**NOTICE OF ADDENDUM
ADDENDUM NO. 2**

**CONTRACT NO. 7939
MADISON MUNICIPAL BUILDING - RENOVATION**

This addendum is issued to modify, explain or correct the original Drawings, Specifications, or Contract Documents and is hereby made a part of the contract documents.

6 TYPICAL FLOOR JUNCTION WITH EXTERIOR WALL AT NEW ADDITION
A353 3" = 1'-0"

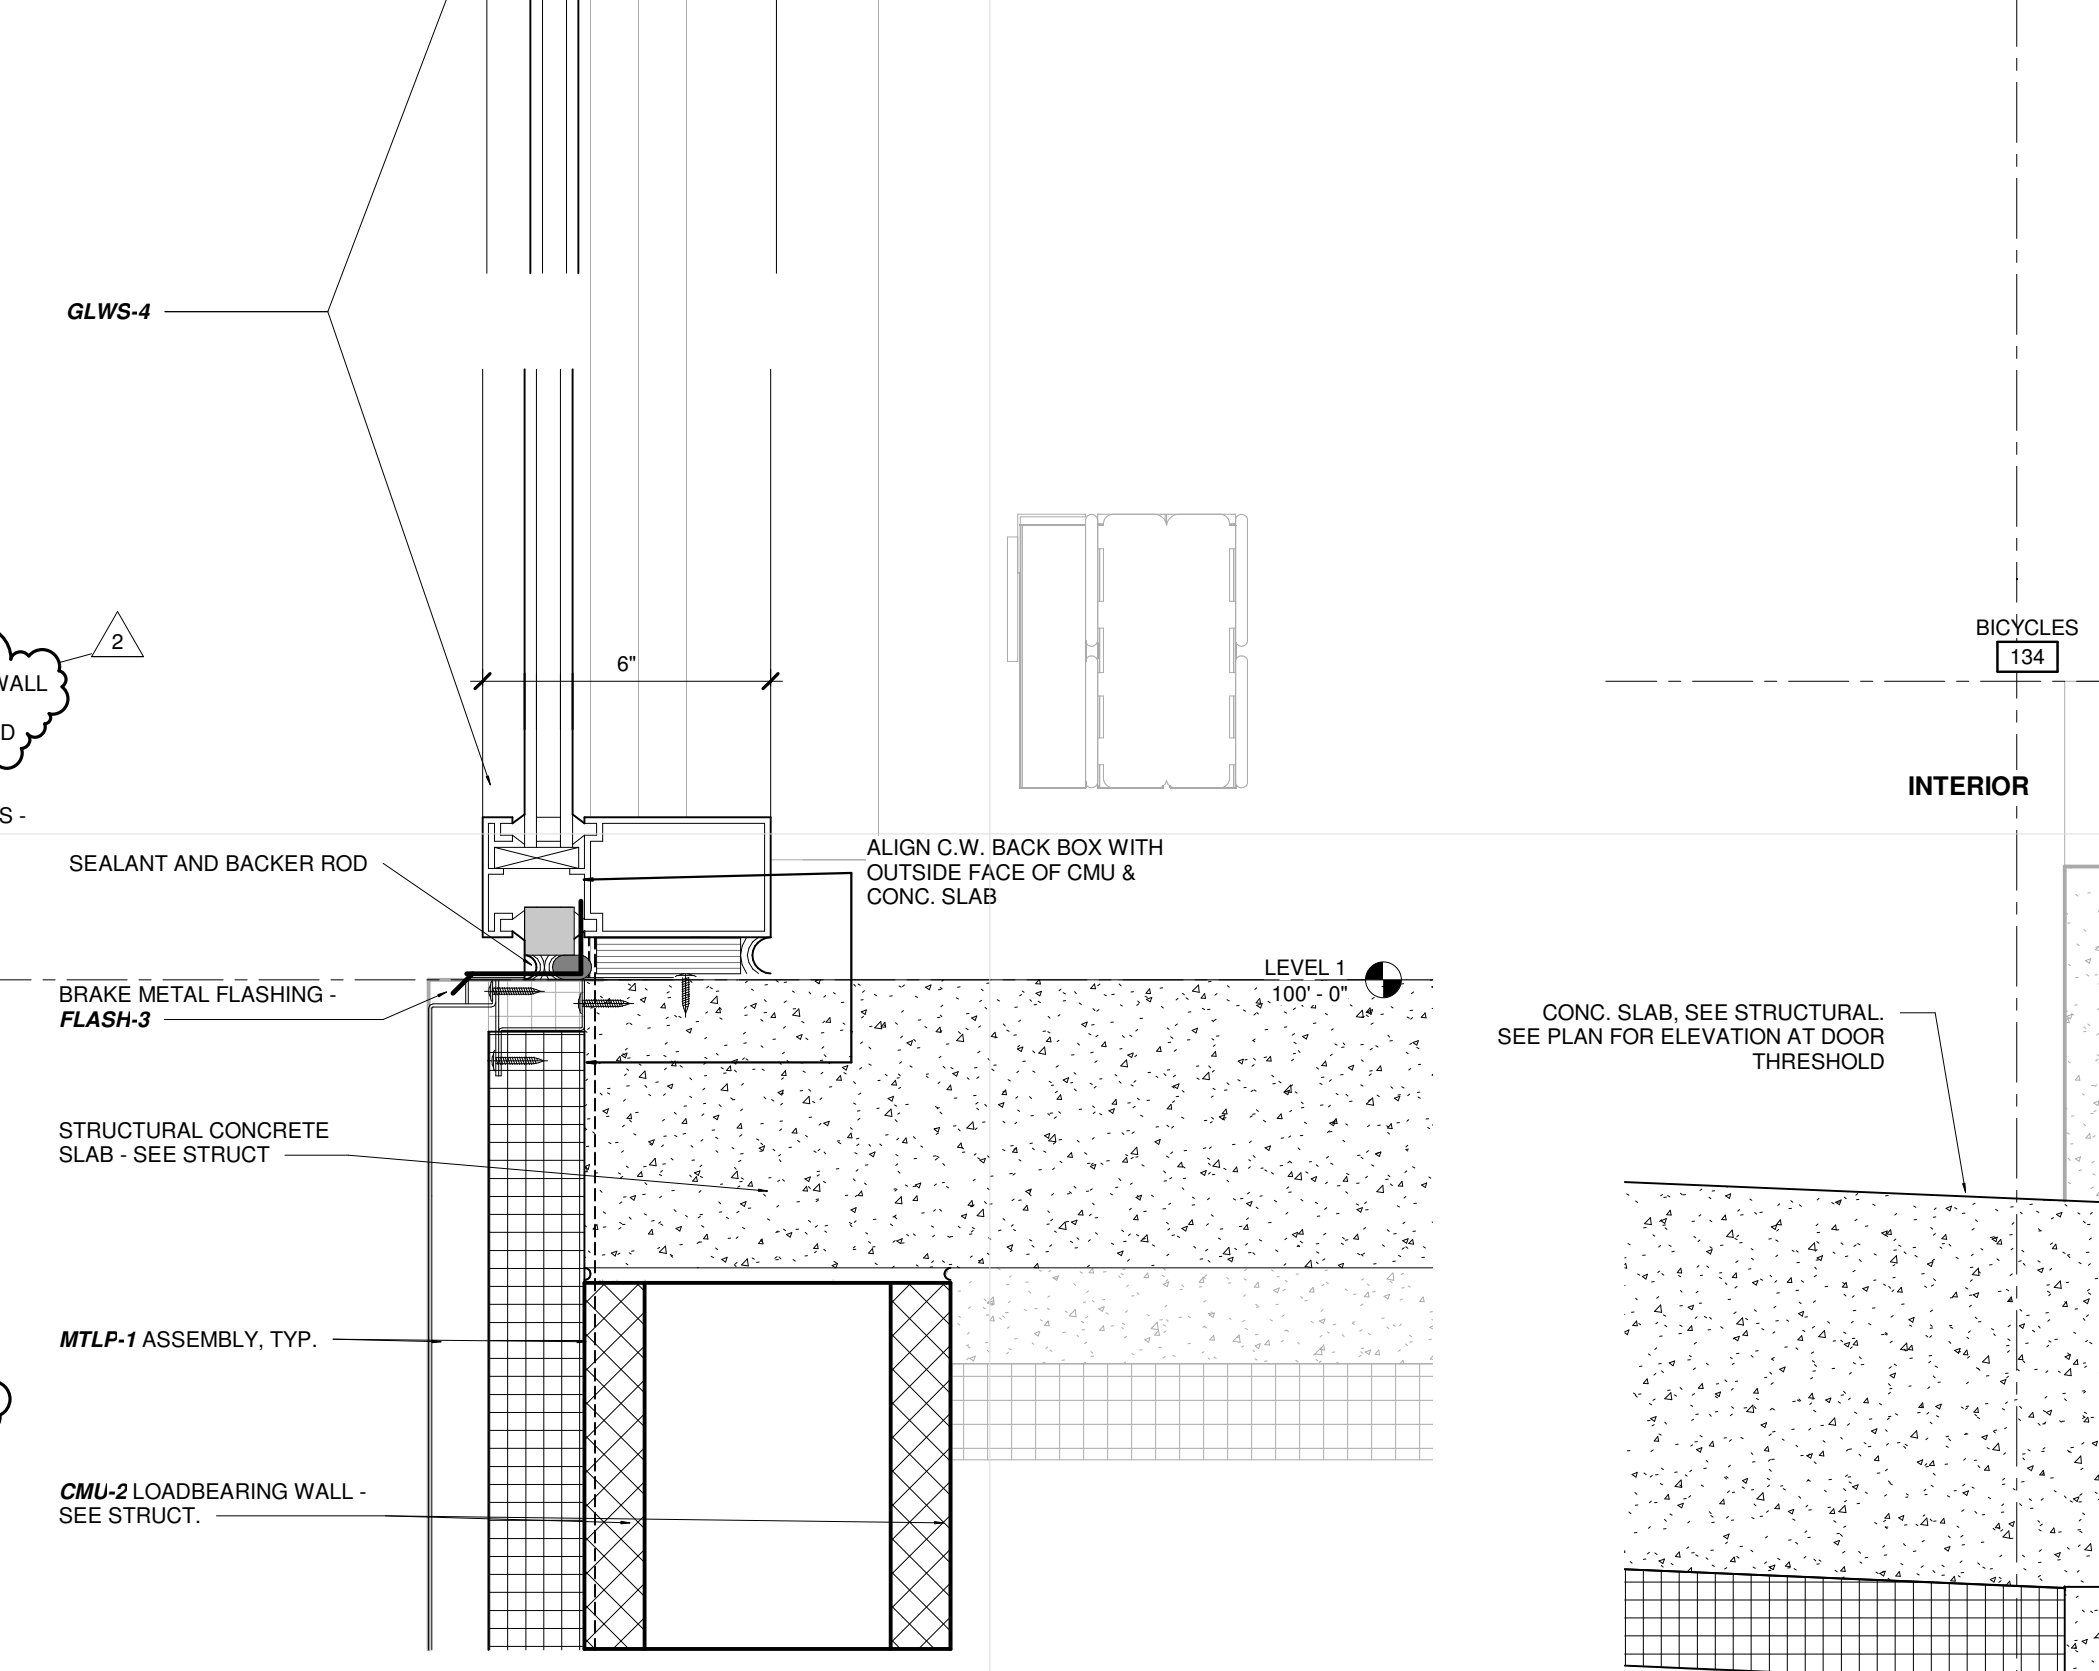
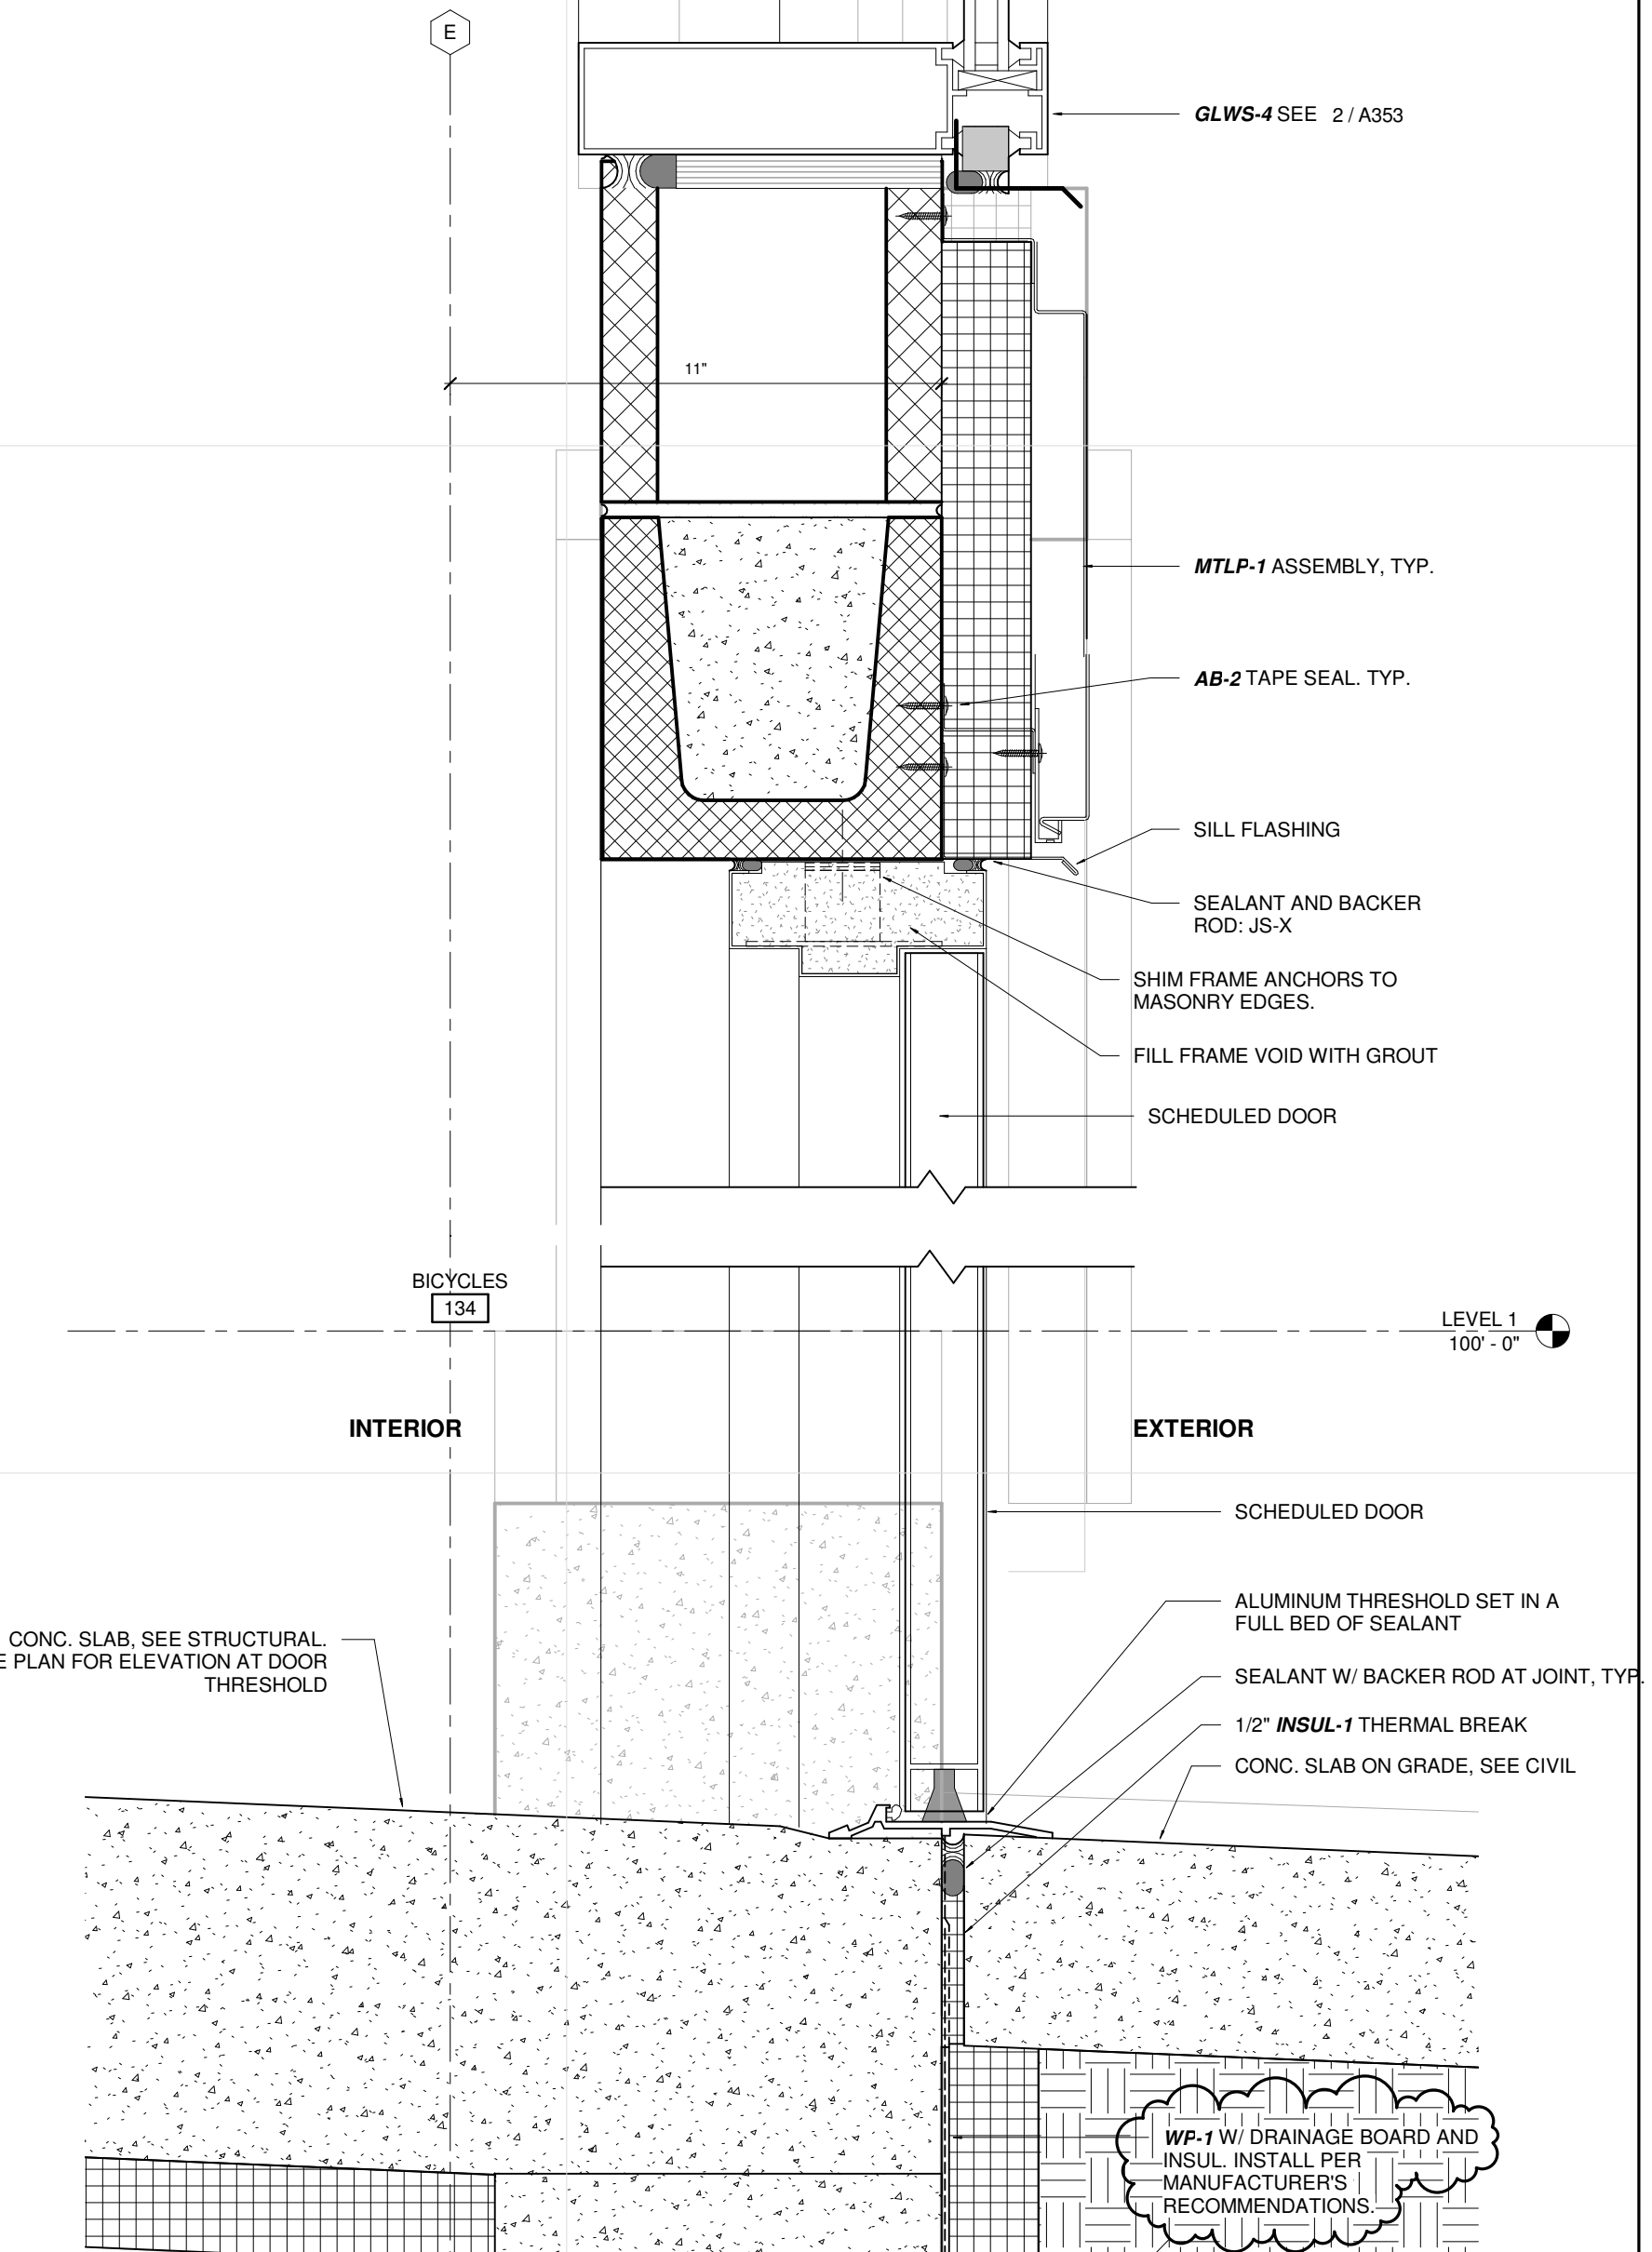
1. Detail 1/A192 Revised to center vestibule on exterior doors.
2. Details 7 and 8/A301. Revised details to clarify waterproofing notes.
3. Details 5,7 and 9/A353. Revised details to clarify waterproofing notes.
